**SUNDRY NOTICES AND REPORTS ON WELLS**  
*Do not use this form for proposals to drill or to re-enter an abandoned well. Use form 3160-3 (APD) for such proposals.*

| 8. Well Name and No.<br>BURTON 6 FEDERAL 1        |
| 9. API Well No.<br>30-015-38226-00-S1             |

**\*\* BLM REVISED \*\* BLM REVISED \*\* BLM REVISED \*\* BLM REVISED \*\* BLM REVISED \*\***

Cimarex Energy Co. of Colorado

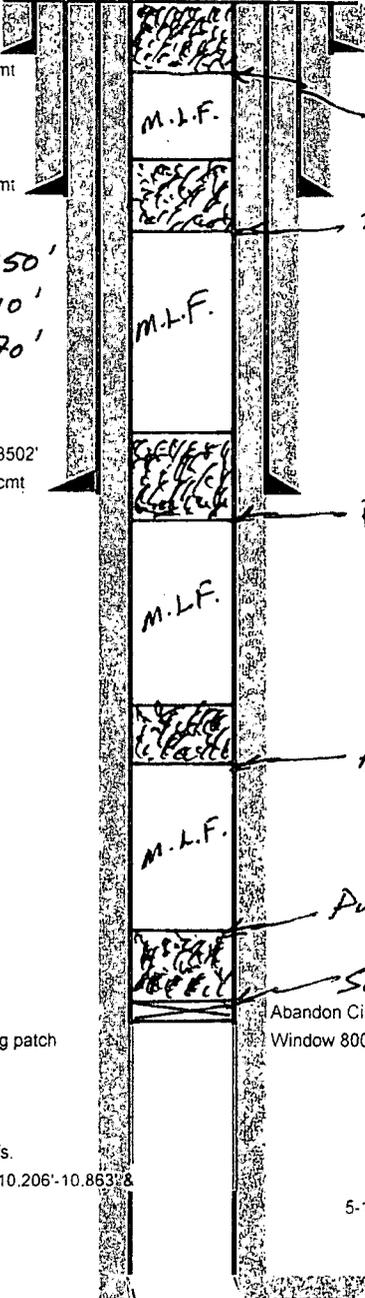
- 1) SET 5-1/2" CIBP @ 8,000'; PUMP 25 SXS.CMT. @ 8,000'-7,820'; CIRC. WELL W/ MLF.
- 2) PUMP 25 SXS.CMT. @ 6,150'-5,990'(T/BNSG.).
- 3) PUMP 30 SXS.CMT. @ 3,660'-3,452'(T/DLWR. 8-5/8"CSG.SHOE); WOC X TAG CMT. PLUG.
- 4) PUMP 25 SXS.CMT. @ 4,655'-1,500'(11-3/4"CSG.SHOE,T/YATES); WOC X TAG CMT. PLUG. 1800' (35 SX)
- 5) MIX X CIRC. TO SURF. 55 SXS.CMT. @ 400'-3'(T/ANHY., 16"CSG.SHOE).
- 6) DIG OUT X CUT OFF WELLHEAD 3' B.G.L.; WELD ON STEEL PLATE TO CSGS. X INSTALL DRY HOLE MARKER. DURING THIS PROCEDURE WE PLAN TO USE THE CLOSED-LOOP SYSTEM W/ A STEEL TANK AND HAUL CONTENTS TO THE REQUIRED DISPOSAL, PER OCD RULE 19.15.17.

CIRC. 55 SXS @ 400' - 3'  
30-015-3822C

Pump 25 SXS @ 1,655' - 1,500' TAG

Pump 30 SXS @ 3,600' - 3,452' TAG

Pump 25 SXS @ 6,150' - 5,990'

Pump 25 SXS @ 8,000' - 7,820'

SET 5-1/2" CIBPC @ 8,000'
